CMDE5

CABINET MEMBER FOR ENVIRONMENT– 12 SEPTEMBER 2013

LONDON ROAD, HEADINGTON – PROPOSED IMPROVEMENTS AND BUS LANE

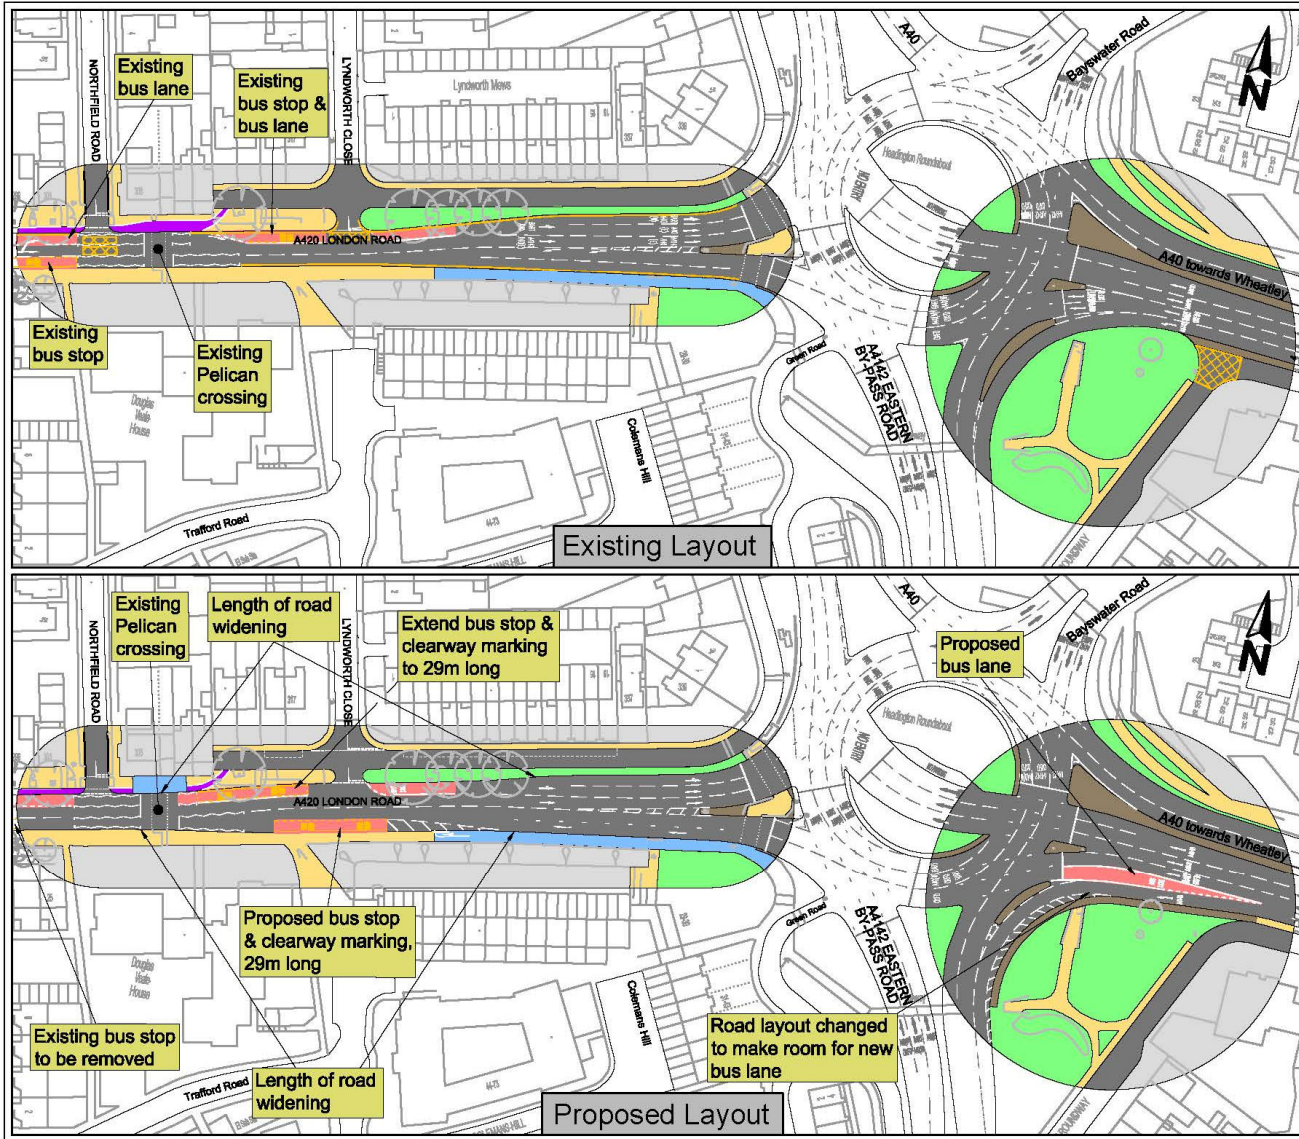
1. Although not objecting to the proposed introduction of the new bus lanes, Cyclox has objected on the grounds that the proposals for London Road make inadequate provision for cyclists. They have suggested 3 changes to the proposed layout; road widening to accommodate a mandatory cycle lane; provision of an off-carriageway segregated cycle facility on the south footway of London Road between the Pelican crossing at Northfield Road to the junction with Gladstone Road; provision of dropped kerbing either side of the relocated Oxford bound bus stop to allow cyclists who feel threatened by traffic to exit the carriageway.

6. The Cyclist Tourist Club (Right To Ride) has taken a similar view as Cyclox and whilst not objecting to the proposed lengths of new bus lane they have objected to the overall proposals on the grounds of inadequate cycle provision. In common with Cyclox, they have suggested some sort

10. A resident of Lyndworth Mews has objected to the proposed changes on London Road relating to the relocation of the Oxford bound bus stop on the south side of the road and the loss of footway and verge space to accommodate the relocated stop.

1. Councillor Roz Smith, the local member for the Headington & Quarry Division, has submitted comments covering 4 aspects of the proposals; Green Road (Toot Hill Butts) exit from the Green Road roundabout; provision of west bound cycling facilities; retention of yellow box markings at junctions and relocation of the Oxford bound bus stop.
2. Issue 1 - The possible conflict with vehicles travelling on the A40 (west) and the Green Road (Toot Hills Butts) exit off the Green Road roundabout.

10. Thames Valley Police (TVP) although not objecting to the proposals for London Road raised concerns relating to particular parts of the proposed layout and operation of the scheme. In particular they queried the inconsistency in approach by the Council to bus lanes located in the approach to roundabouts, and used Banbury Road as an example. The general principle has been to terminate bus lanes a set distance back from the roundabout in order to accommodate left turning traffic. This is not the case at the Green Road roundabout where left turning traffic onto the A4142 Eastern Bypass uses the segregated left turn lane.

12. TVP commented on the proposal to lengthen the last London bound bus stop on London Road, located to the immediate west of Lyndworth Close, and the impact on forward visibility to the adjacent Pelican crossing. The proposed layout as consulted on would result in slightly reduced forward visibility to the crossing for drivers travelling westwards along London Road when 2 buses are at the bus stop. In order to address this concern it is recommended that the proposal to lengthen this bus stop is amended to provide a single 19 metre length bus stop.

- (a) **the proposed length of new bus lane on the A40 London Road at the approach to the Green Road roundabout and that that length of bus lane should have an appropriately coloured surface treatment applied to it;**
- (b) **the proposed bus lane extension on the A40 London Road at the access to the Thornhill Park & Ride;**
- (c) **the proposed London Road Improvement Scheme with the following amendments:**

- 1. **Additional survey work to be carried out to determine the level of use for the Green Road exit and gauge the impact it might have on local traffic;**
- 2. **Preparatory work to be carried out for the formal consultation to close the Green Road exit from the Green Road roundabout to motorised vehicles;**
- 3. **Formal consultation to be carried out in connection with the permanent closure of the Green Road exit from the Green Road roundabout;**
- 4. **Monitoring of the new road layout at the Green Road roundabout to be carried out for a period of 6 months from opening to determine if the permanent closure of the Green Road exit from the Green Road roundabout is required.**

- 1. **The proposed length of the London bound bus stop on the north side of the road (west of Lyndworth Close) be reduced to 19 metres;**

2. **Retention of the yellow box junction markings at the junctions of London Road with Northfield Road and Lyndworth Close;**
 3. **Provision of west bound cycle facilities on London Road be investigated separately to this scheme.**
- (d) **to instruct that further consideration be given to the concerns raised by Cyclox regarding the merging of cyclists and general traffic on the existing carriageway shared use footway/cycleway.**
